Memorandum Department of Planning, Public Works & Parks

RE: Chesterfield Blue Valley, Proposed Lot 10 (Premium Outlets): A Site Development Section Plan, Landscape Plan, Lighting Plan, Architectural Elevations, and Architect's Statement of Design for a 50.72 acre tract of land zoned "PC" Planned Commercial District in the northeast corner of the development located on the north side of Olive Street Road, west of its intersection with Chesterfield Airport Road.

Re: 4/9/12 Planning Commission Comments
 St. Louis Premium Outlets
 Chesterfield, MO

OVERALL AERIAL PERSPECTIVE

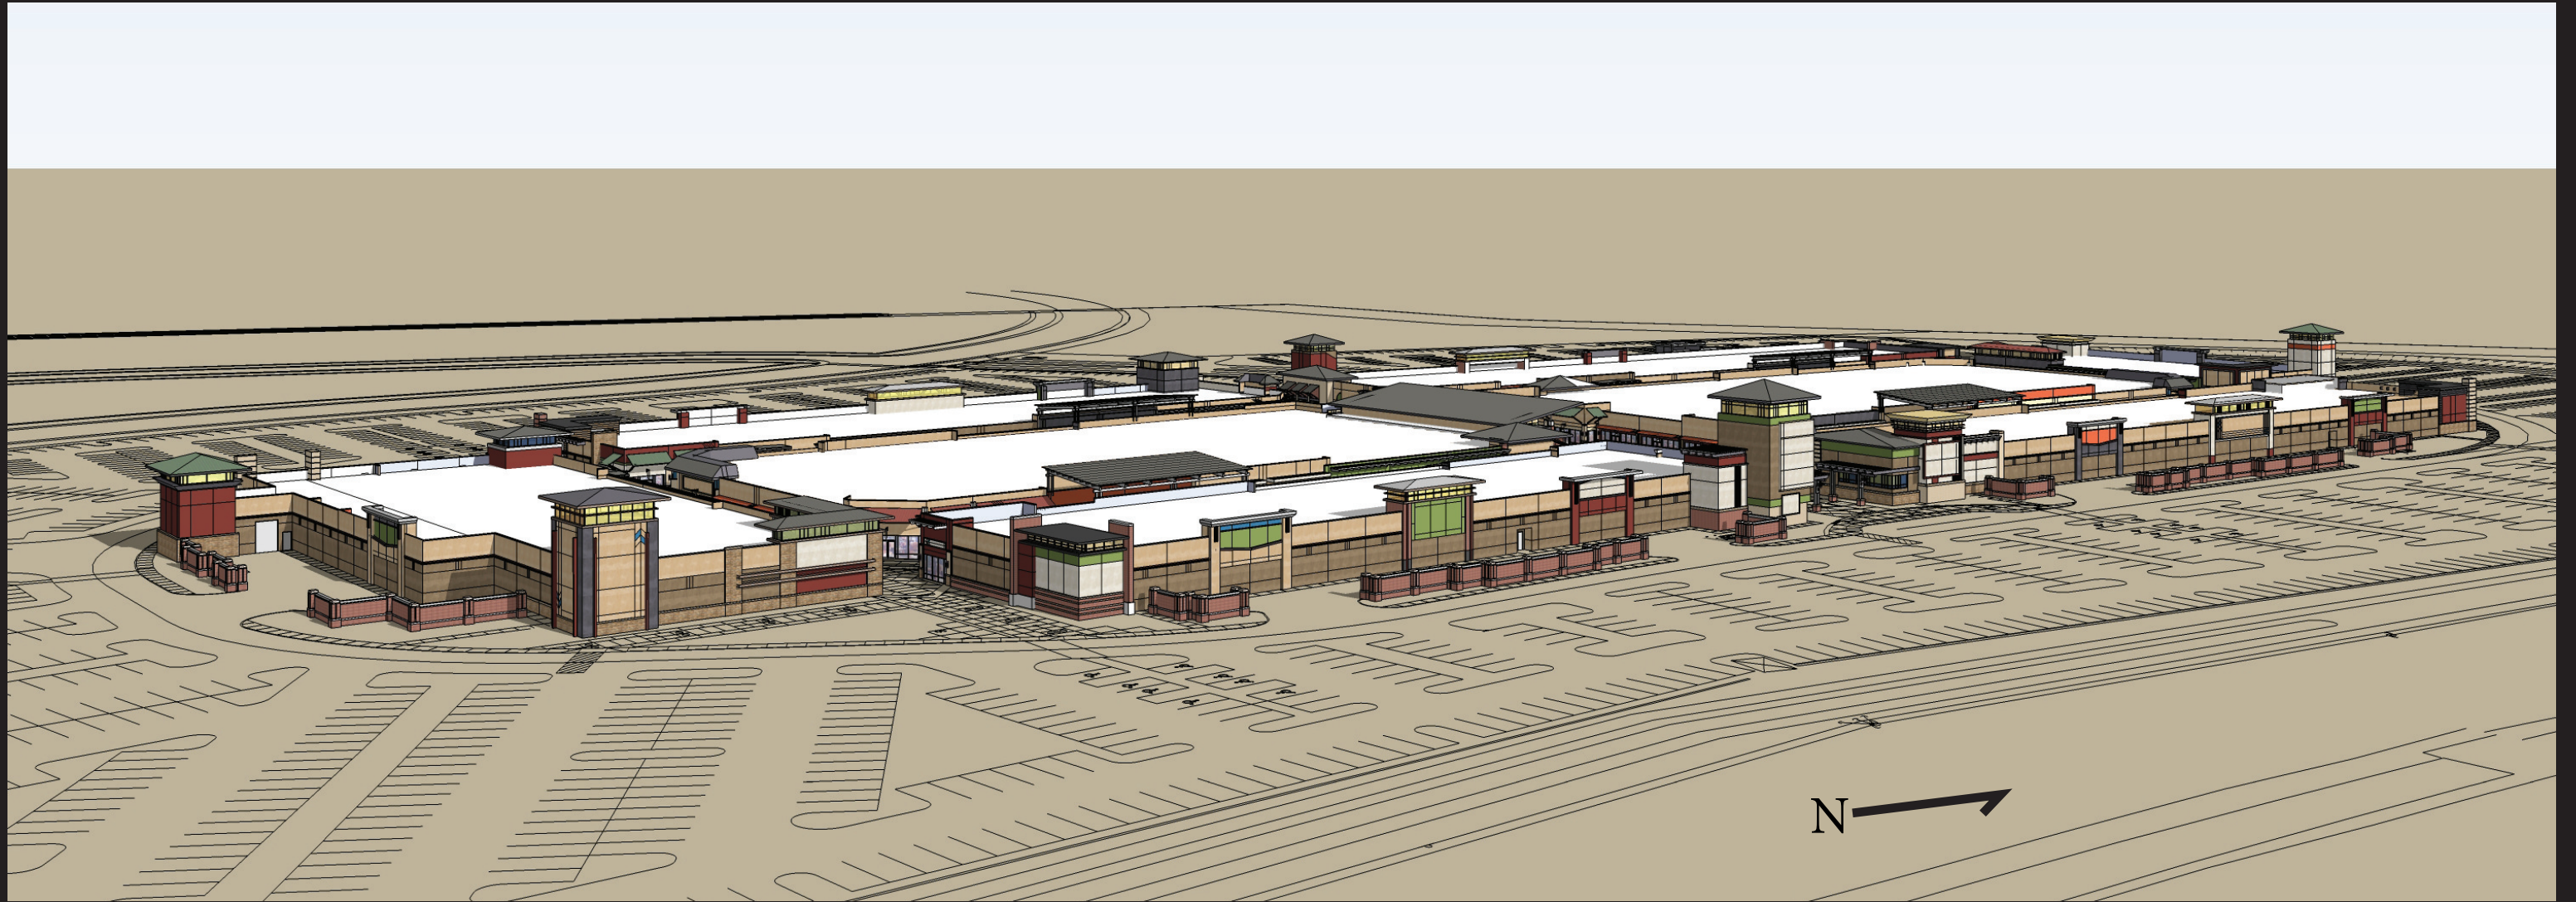
4. We have submitted overall North, South, East and West perimeter elevations along with an aerial perspective to aid the commission and committee's with the overall development building massing.

OVERALL COLOR ELEVATIONS

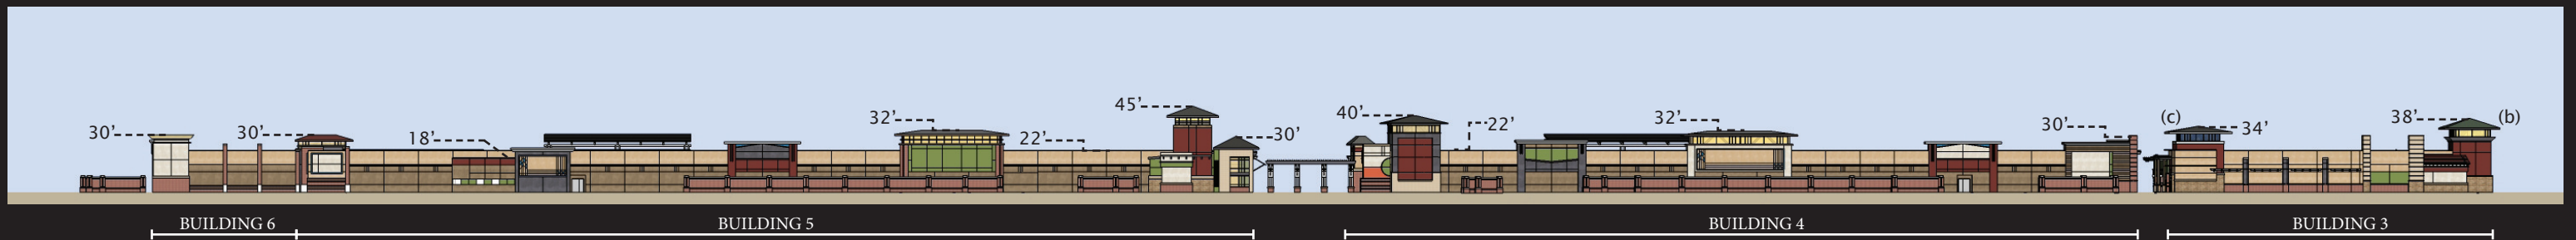
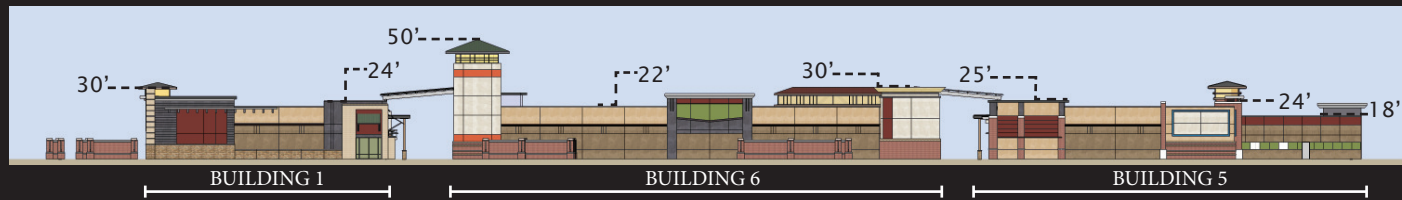
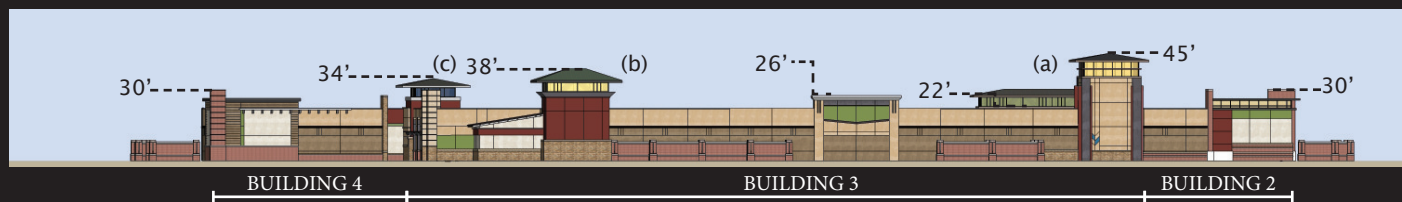
- 1. Add additional pedestrian markings to insure safe pedestrian path from the parking area to the inner ring road at the north side of the building closest to the levee.*
- 2. Additional plantings be considered after bridge construction design is completed by MoDOT to be reviewed by Staff in accordance with the City Code.*
- 3. Limit the height of the towers to 45 feet*

Height of the Towers: Based on the recommendation to reduce the heights of four (4) of the proposed towers to a maximum of forty-five (45) feet, the Applicants reviewed their design and submitted additional information with changes. Eight (8) areas of the elevations which exceeded thirty-four (34) feet were reviewed and the table below shows the proposed heights.

Building	Tower Height (PC Submittal)	Tower Height (P&PW Submittal)	Height Reduction
1	40'-0"	38'-0"	-2'-0"
2	65'-0"	60'-0"	-5'-0"
3	50'-0"	45'-0"	-5'-0"
3	38'-0"	38'-0"	0
3	34'-6"	34'-6"	0
4	45'-0"	40'-0"	-5'-0"
5	50'-0"	45'-0"	-5'-0"
6	50'-0"	50'-0"	0

Based upon our review, we propose reductions to 5 out of the 8 towers. In 2 instances, we propose towers that exceed 45 ft; (1) A 60' tower located at Bldg. 2 and (2) A 50' tower located at Bldg. 6. The revised breakdown of each tower in the project and their proposed height is, as follows:

<i>Bldg.</i>	<i>Orig. Tower Height</i>	<i>Proposed Tower Height</i>	<i>Reduction in Height</i>
1	40'-0"	38'-0"	(-2'-0")
2	65'-0"	60'-0"	(-5'-0")
3	50'-0" (a)	45'-0"	(-5'-0")
3	38'-0" (b)	38'-0"	0
3	34'-6" (c)	34'-6"	0
4	45'-0"	40'-0"	(-5'-0")
5	50'-0"	45'-0"	(-5'-0")
6	50'-0"	50'-0"	0

- **The Tallest Towers only front the Highway.** It is critical that we maximize project visibility over longer distances and help orient our customer travelling at higher speeds on I-64. Therefore, we propose a 60' tower (reduced from 65') located at building 2 by the east entry and a 2nd but smaller tower of 50' located at Building 6 by the northeast entry.

Additionally the centerline elevation of I-64 is 472' at the levee and 470' at the eastern edge of our property. The proposed bottom elevation of the tower is 465' – 6' below the mean elevation of the highway. The 60' tower will only be 54' higher than the roadway elevation.
